Access Compliance Report Public Rights-of-Way (Curb Ramps)

Main Street: E_VINE_ST Cross Street: S_ESPLANADE_ST Location: SE

ADA ID: RPAT210927115429 Ramp Type: Type 4 - Parallel Initial Pass/Fail: Fail Overall Compliance: No Severity Score: 4

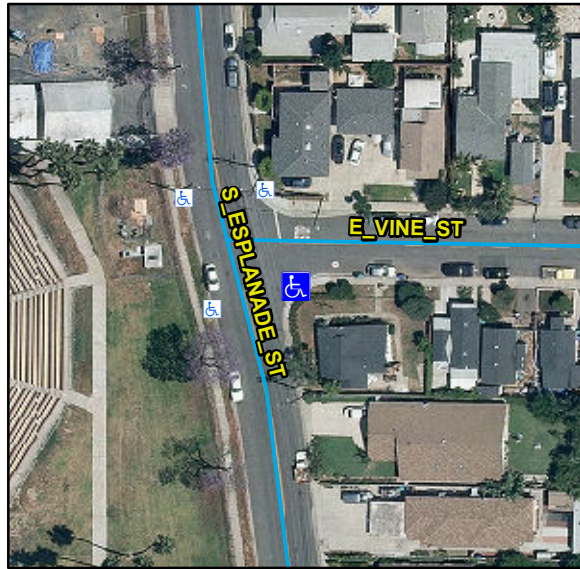
Compliance	Description	Data	Compliance	Description	Data
N/A	Ramp Length LT (in)	103	N/A	Ramp Length RT (in)	73
Yes	Ramp Width LT (in)	48	No	Ramp Width RT (in)	47
Yes	Ramp Run Slope LT (%)	5.1	Yes	Ramp Run Slope RT (%)	6.2
Yes	Ramp Cross Slope LT (%)	0.3	Yes	Ramp Cross Slope RT (%)	0.1
N/A	Landing Present	N/A	N/A	DWS Provided	N/A
N/A	Landing Length (in)	N/A	N/A	DWS Contrast	N/A
N/A	Landing Width (in)	N/A	N/A	DWS Length (in)	N/A
N/A	Landing Run Slope (%)	N/A	N/A	DWS Full Width	N/A
N/A	Landing Cross Slope (%)	N/A		DWS Offset Type	N/A
N/A	Landing Movement Obstructed?	N/A	N/A	DWS Offset Left (in)	N/A
	Landing Movement Type	N/A	N/A	DWS Offset Right (in)	N/A
N/A	Landing Shared	N/A			
N/A	Clear Space	Yes			
N/A	Clear Space To Crosswalk (in)	N/A			
N/A	Marked Crosswalk 1	No	N/A	Marked Crosswalk 2	No
	Crossing 1 Direction	N		Crossing 2 Direction	W
	Marked Crosswalk 1 Width (in)	N/A		Marked Crosswalk 2 Width (in)	N/A

Remove & Replace Curb Ramp With Two New Directional Ramps or Equivalent.
